QST JAN 11 WATTMETER

TWO A TO D CONVERTER BD REQUIRED

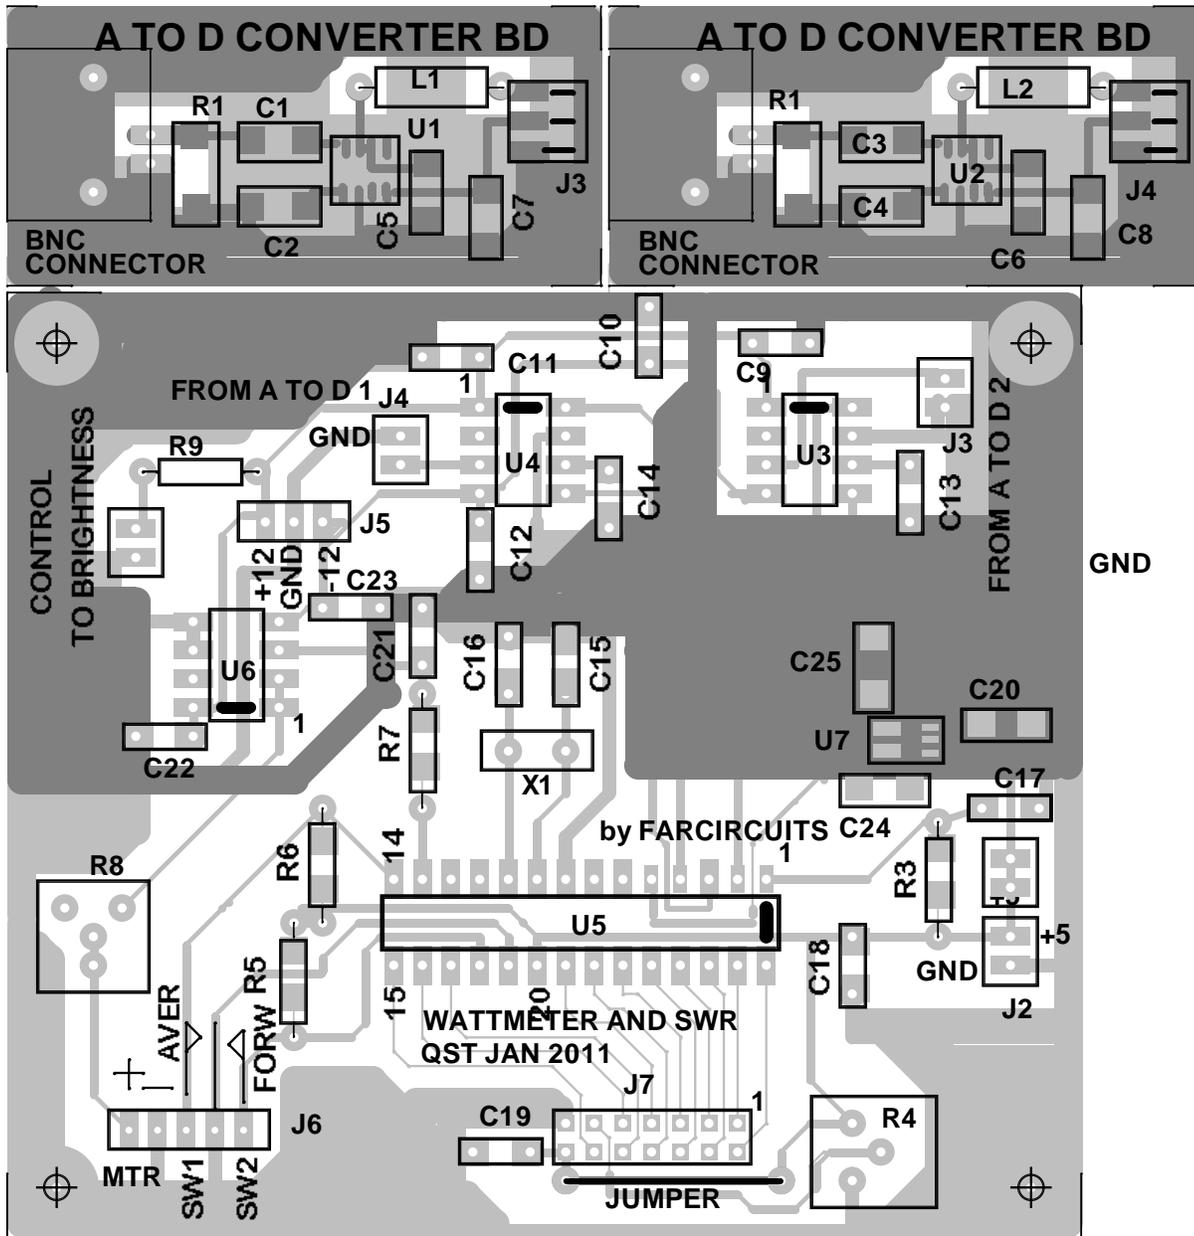
NOTE: U7, C20, C24, AND C25 ARE MOUNTED ON THE BOTTOM OF THE BOARD

NOTE: THE SCHEMATIC IN QST SHOWS TWO R1 RESISTORS, AND NO R2 ONE OF THESE R1'S IS R2

THE PARTS LIST, R1 AND R2 AND THE SAME VALUE
